Access Compliance Report

Public Rights-of-Way

(Curb Ramps)

Intersection ID: 2822	Main Street: CARDINAL_POINT_RD	Cross Street: GOLDENBLUSH_CR	Location: S
ADA ID: 0EF3CF0006EF	Ramp Type: Perp	Initial Pass/Fail: Fail	Overall Compliance: No
Severity Score: 10			
Codes/Mitigation Info/Possible Solution		Field Measurements/Component Compliance

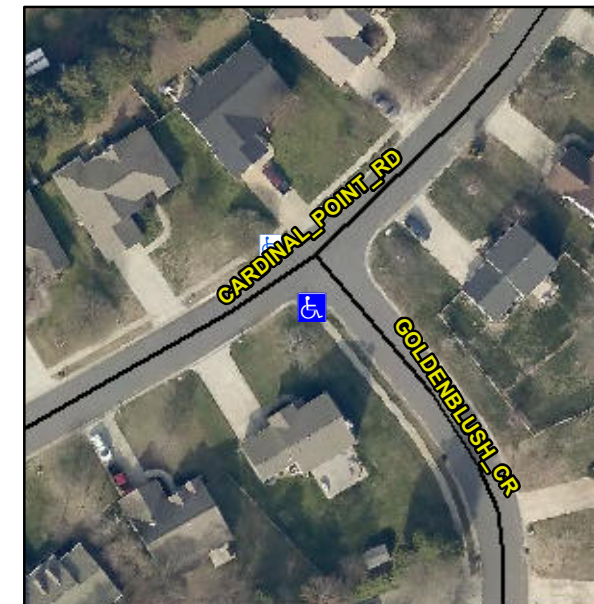
Not Found, R304.5.1

Compliance	Description	Data	Compliance	Description	Data
N/A	Ramp Length (in)	48.0	Yes	Ramp Slope (%)	5.0
No	Ramp Width (in)	43.0	Yes	Ramp XSlope (%)	3.3
N/A	Flare Type LT	N/A	N/A	Flare Type RT	N/A
N/A	Flare Slope LT (%)	N/A	N/A	Flare Slope RT (%)	N/A
N/A	Flare Traversable LT?	N/A	N/A	Flare Traversable RT?	N/A
N/A	Landing Length (in)	N/A	N/A	DWS Provided?	N/A
N/A	Landing Width (in)	N/A	N/A	DWS Contrast?	N/A
N/A	Landing Slope (%)	N/A	N/A	DWS Length (in)	N/A
N/A	Landing X Slope (%)	N/A	N/A	DWS Full Width?	N/A
N/A	Landing Curb? (Y/N)	N/A	N/A	DWS Offset (in)	N/A
N/A	Shared Landing?	N/A			
N/A	Gutter Ponding?	N/A	N/A	Gutter Slope (%)	N/A
N/A	Gutter Lip Ht (in)	N/A	N/A	Gutter X Slope (%)	N/A
N/A	Painted X Walk1?	No	N/A	Painted X Walk2?	N/A
	X Walk 1 Direction	To NW		X Walk 2 Direction	N/A
N/A	X Walk 1 Width (in)	N/A	N/A	X Walk 2 Width (in)	N/A
	X Walk 1 Slope (%)	3.1		X Walk 2 Slope (%)	N/A
	X Walk 1 X Slope (%)	4.9		X Walk 2 X Slope (%)	N/A

Remove & Replace Entire Ramp.
